From: [Phil](#) [REDACTED]
To: [Kayla](#) [REDACTED]
Cc: [Richard](#) [REDACTED]
Subject: FW: Autocar with possible loose air transfer clamps
Date: Thursday, March 29, 2018 12:41:09 PM
Attachments: [image004.png](#)

Issue: There ~~could be a gap~~ **is no gap** in the trunnion area of the v-band clamp indicating the clamp is not meeting its intended function.

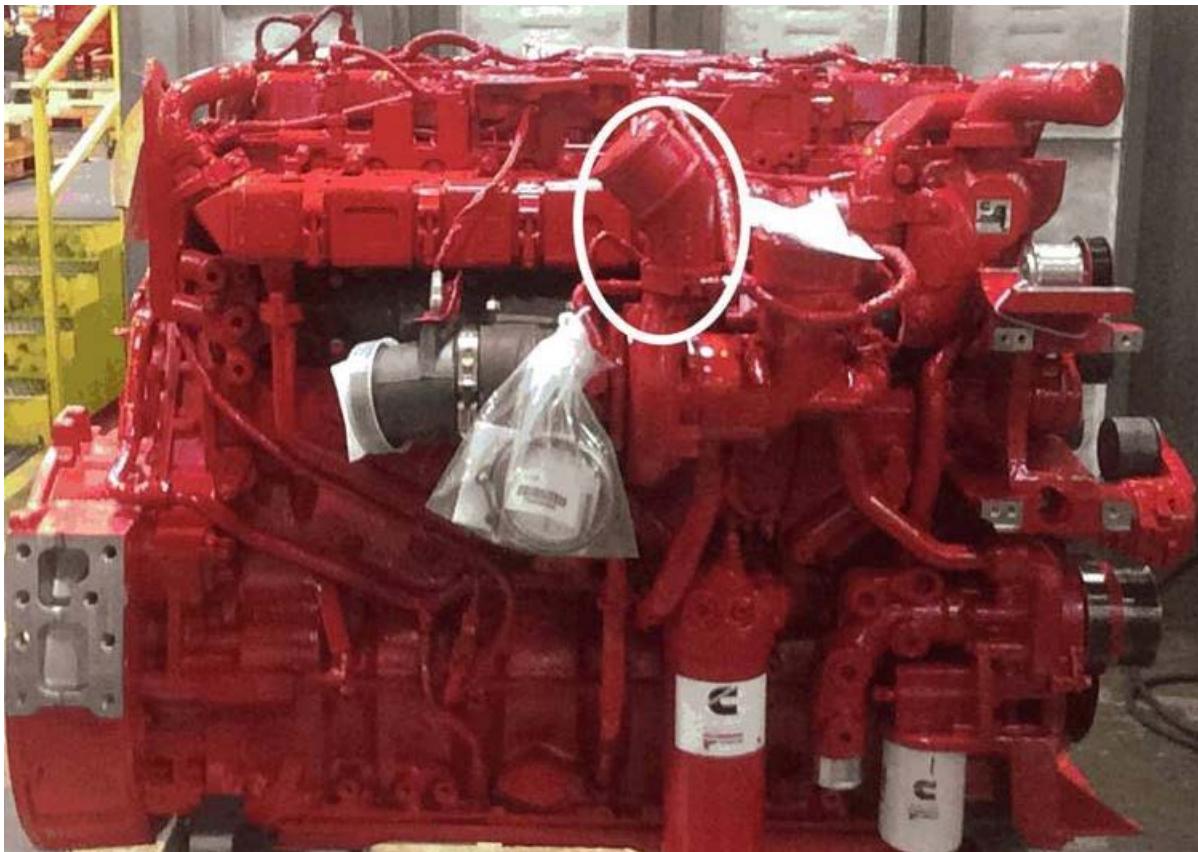
Here is a photo of the suspect inlet and clamp for reference...

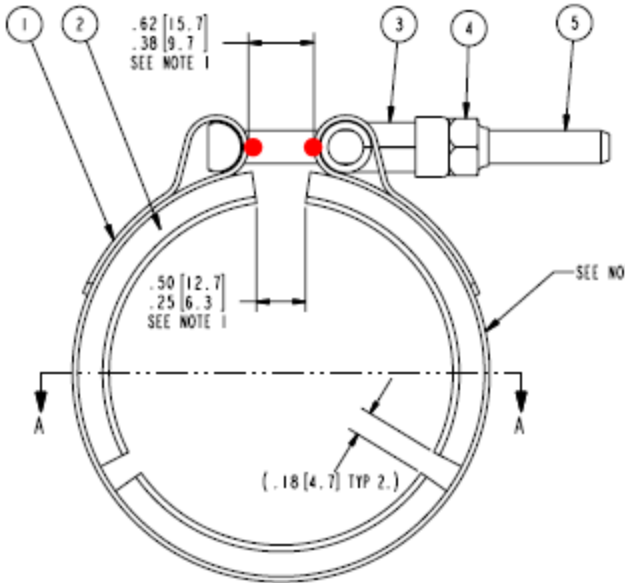
In addition, if the tech can check to see if the two trunnions are touching together (red areas in print below), this likely means a bad clamp and it will need to be replaced.

If a gap like shown below, it should be good...but it still wouldn't be a bad idea for the tech to check it.

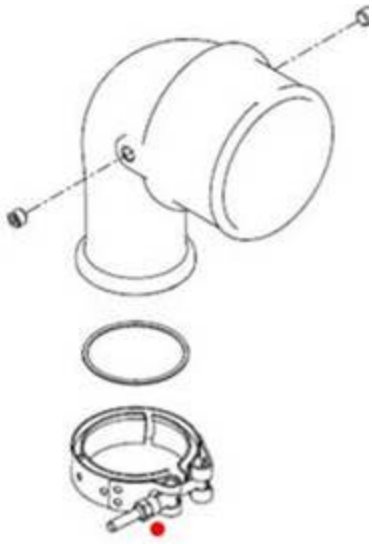
Possible fail mode: Loose air transfer pipe/air leak.

Fix: Ensure that the clamp is torqued to 75 in. lbs and report any defective clamps with ESN's to JEP CQA.
